**CITY OF NOVI CITY COUNCIL
JUNE 15, 2020**

SUBJECT: Consideration for tentative approval of the request of BC Novaplex, LLC, for Novaplex, JZ19-37, to rezone from OST, Office Service Technology to RM-2, High-Density Multiple Family Residential on land located on the west side of Haggerty Road, north of Twelve Mile Road in Section 12. The applicant is proposing to develop a 270-unit multiple-family residential development on approximately 22 acres of land.

SUBMITTING DEPARTMENT: Community Development Department - Planning

ORIGINAL ISSUE DATE:
 JULY 26, 2019
 PEA JOB NO. 2015-296
 SCALE: 1" = 50'
 DRAWING NUMBER:
C-2.3

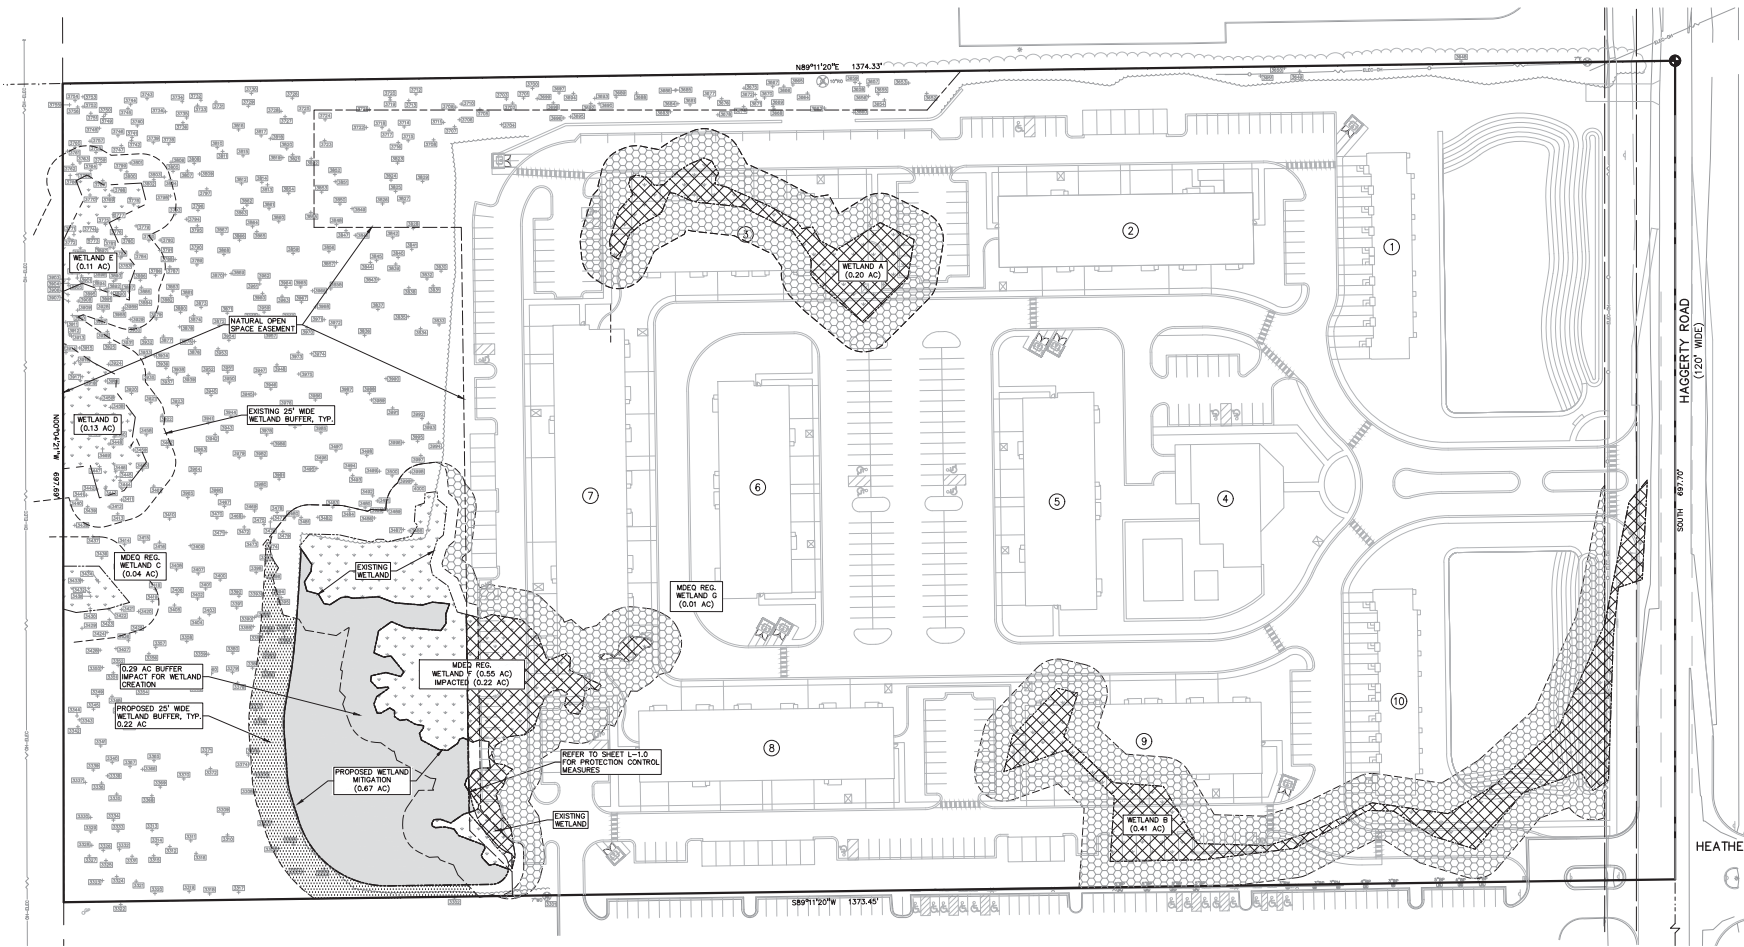
The Plan indicates seven (7) areas of existing wetland on the development site (Sheet C-2.3; *Wetland Impact Plan*). The Plan currently proposes impacts to four (4) of these wetlands (i.e., Wetlands A, B, F, and G). Wetlands C, D, and E are proposed to be preserved. It should be noted that the current Plan does not appear to indicate and quantify the proposed impacts to the existing 25-foot wetland setbacks. A description of the apparent wetland impacts follows. The following table (Table 1) summarizes the existing wetlands and the proposed wetland impacts:

ORIGINAL ISSUE DATE:
 JULY 26, 2019
 PEA JOB NO. 2015-296
 SCALE: 1" = 50'
 DRAWING NUMBER:
C-3.0

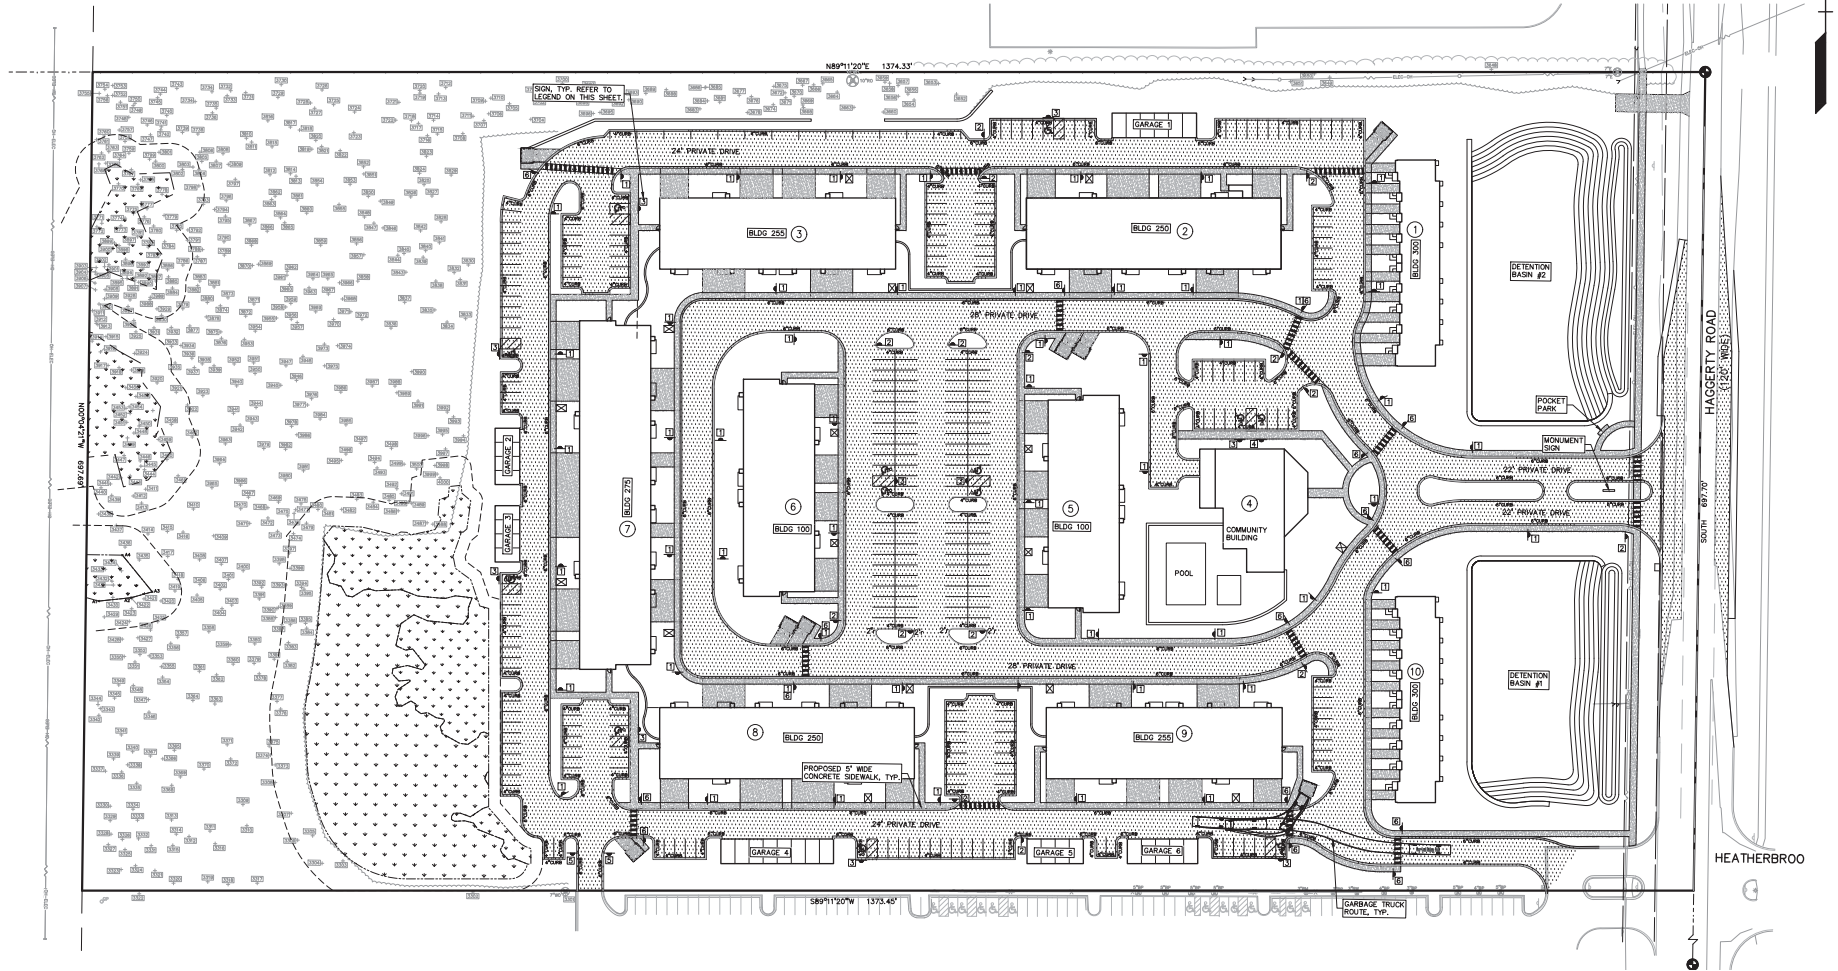
- c. The stop sign detail shown on sheet C-9.0 indicates a sign size of 24". Stop signs are required to be a minimum of 30".
2. The applicant should provide the following notes and details related to the proposed signing.

ORIGINAL ISSUE DATE: JULY 26, 2019
PEA JOB NO. 2019-298
SCALE: 1" = 50'
DRAWING NUMBER:
L-1.0

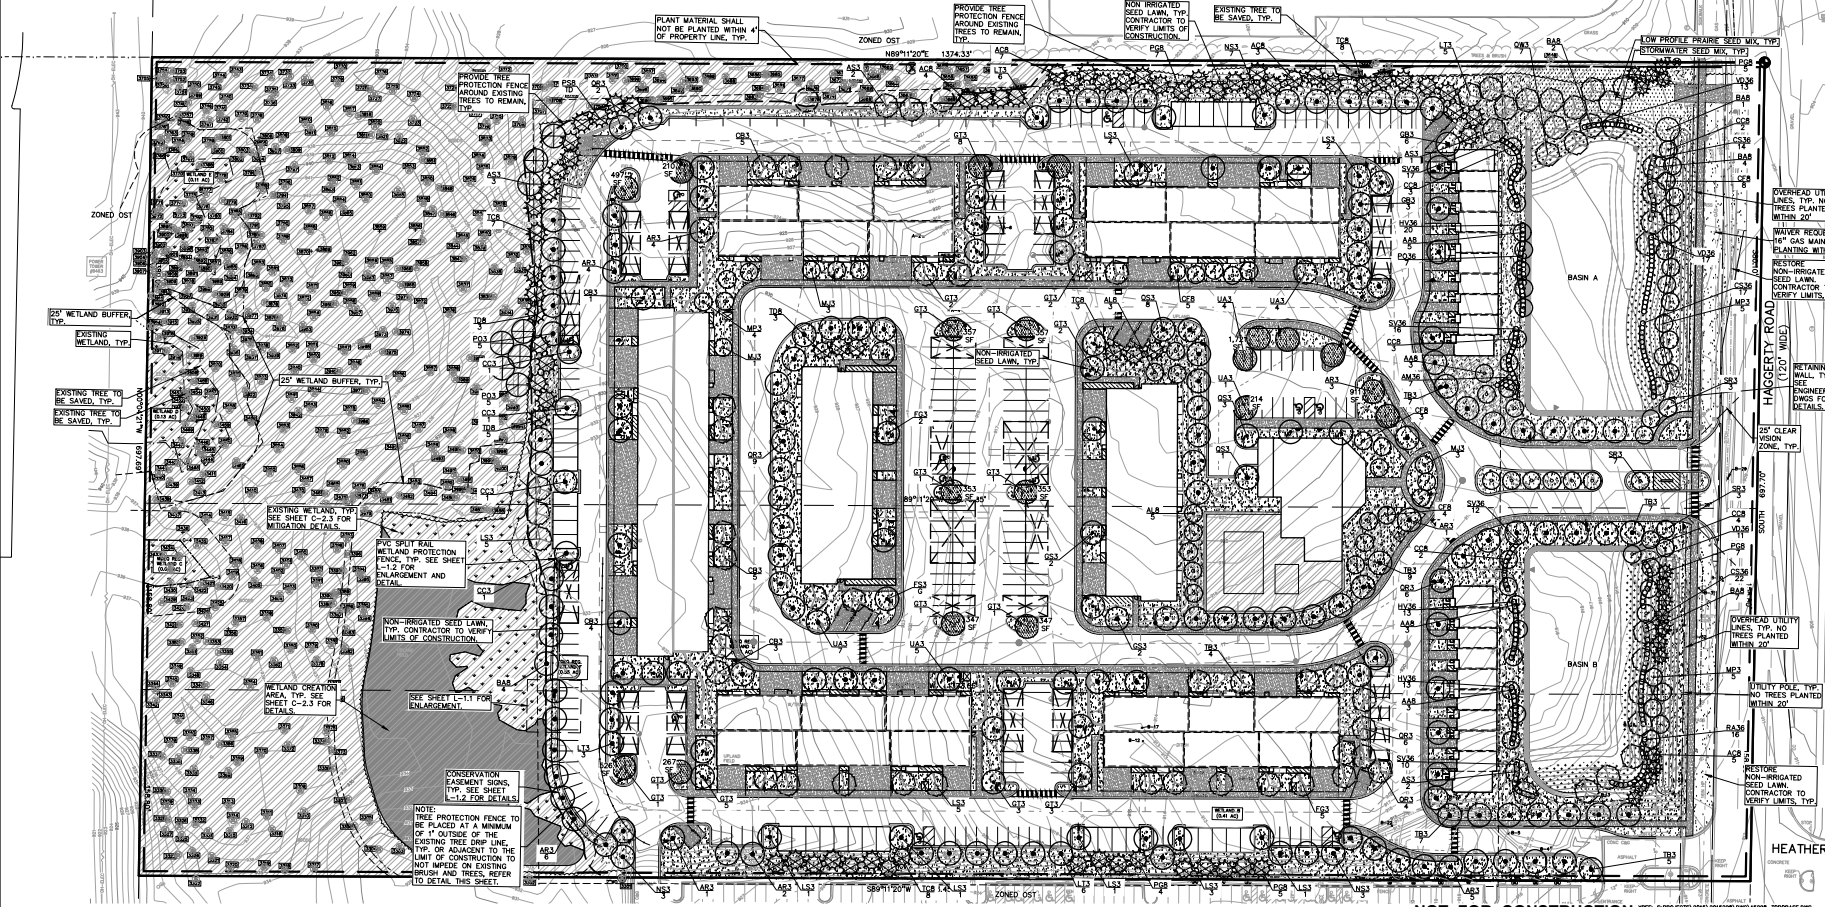
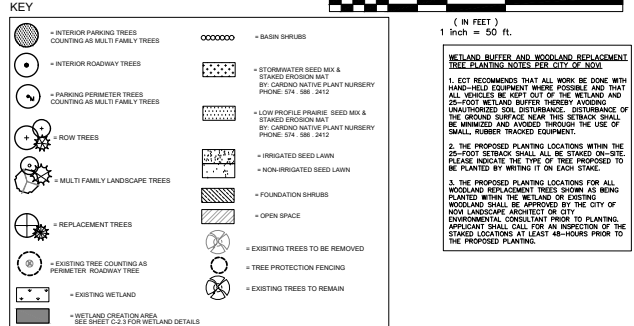
Please replace the Waivers Requested on Sheet L-1.0 with the above list of deviations required.

6. It should be noted that the *Preliminary Landscape Plan* (Sheet L-1.0) indicates that woodland replacement trees are to be planted within the regulated woodland areas remaining on the west side of the project site. The Plan also notes that replacement planting numbers and locations within the woodland will be jointly determined by the applicant's landscape architect and the City of Novi's Landscape architect. Any trees that cannot be planted without bringing harm to the existing woods will be replaced by a contribution to the City of Novi Tree Fund.

7. The Plan appears to indicate that 140 Woodland Replacement Credits will be planted on-site and the remainder (343) shall be paid into the City of Novi Tree Fund. Sheet L-1.1 (*Prelim Landscape Calculations*) and Sheet L-1.0 (*Preliminary Landscape Plan*) contain some discrepancies. The *Preliminary Landscape Plan* appears to indicate a total of 104 deciduous replacement trees (104 Credits at 1-to-1 replacement ratio) and 54 evergreens (36 Credits at 1.5-to-1 replacement ratio) are to be planted. The information regarding replacements provided on the *Prelim Landscape Calculations* sheet differs slightly. Please review and revise the landscaping sheets to ensure that the woodland removal and proposed replacement information is consistent.

Figure 1. City of Novi Regulated Wetland & Woodland Map (approximate project property boundary shown in red). Regulated Woodland areas are shown in green and Regulated Wetland areas are shown in blue.

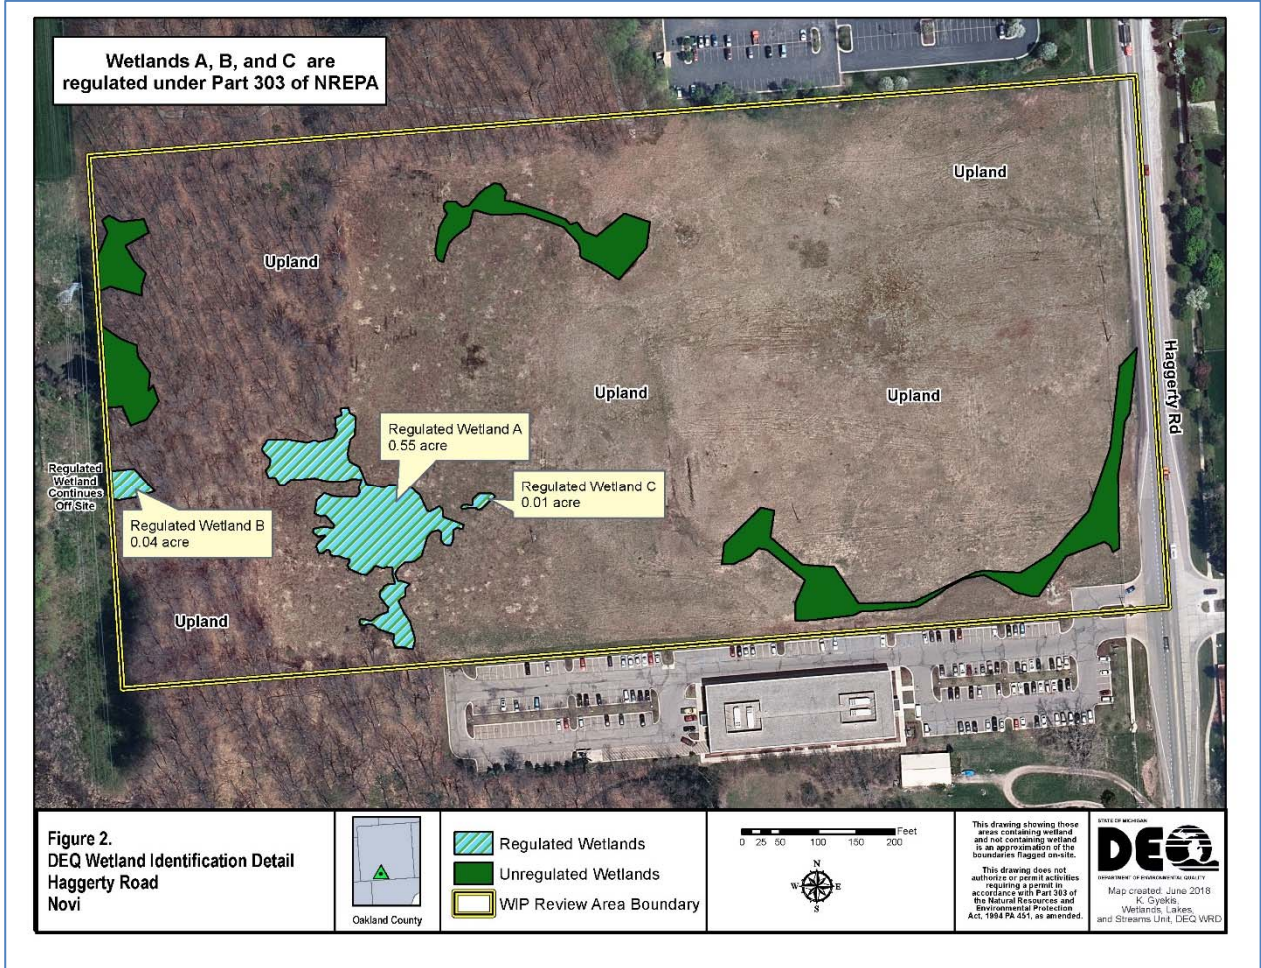
ECT’s in-office review of available materials included the City of Novi Regulated Wetland and Woodland map, USGS topographic quadrangle map, NRCS soils map, USFWS National Wetland Inventory map, and historical aerial photographs. The site includes areas indicated as City-regulated wetland on the official City of Novi Regulated Wetland and Woodland Map (see Figure 1).

Figure 1. City of Novi Regulated Wetland & Woodland Map (approximate project boundary shown in red). Regulated Woodland areas are shown in green and Regulated Wetland areas are shown in blue.

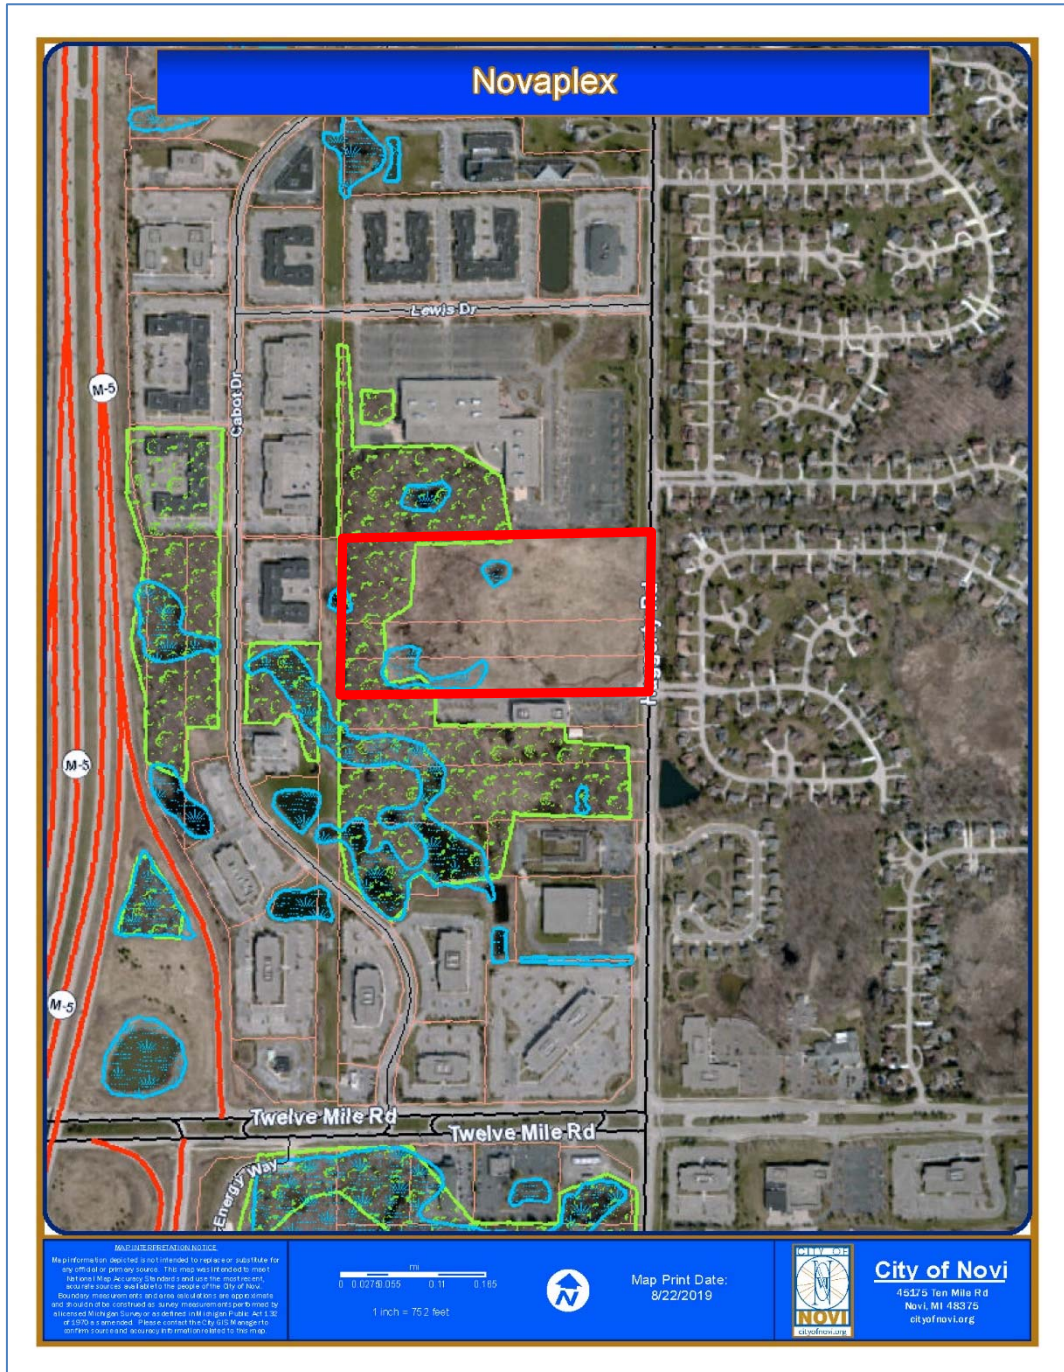
ECT has reviewed the City of Novi Official Woodlands Map and completed an onsite Woodland Evaluation on August 20, 2019. ECT's in-office review of available materials included the City of Novi Regulated Woodland map and other available mapping. The subject property does include areas indicated as City-regulated woodland on the official City of Novi Regulated Wetland and Woodland Map (see Figure 1). The majority of the site has been previously cleared of trees, however, as shown on the *Topographic Survey* (Sheet C-1.0), a forested buffer remains along the western portion and a section of the northwester edge of this parcel. Sections of this remaining forested area appear to exceed 300 lineal feet in width. The remaining woodland areas consists of a high-quality beech-sugar maple forest that has a dense canopy dominated by beech and sugar maple trees with some ash, basswood, oak, elm, black cherry, and walnut. Ironwood is a dominant understory tree along with beech and sugar maple saplings. Shrubs consist of predominantly spicebush with some witch-hazel, viburnum and common elderberry. Ground cover within this woodland includes creeping strawberry-bush, woodbine, Jack-in-the-pulpit, Solomon's seal, Christmas fern, bloodroot, beech drops, and mayapple.
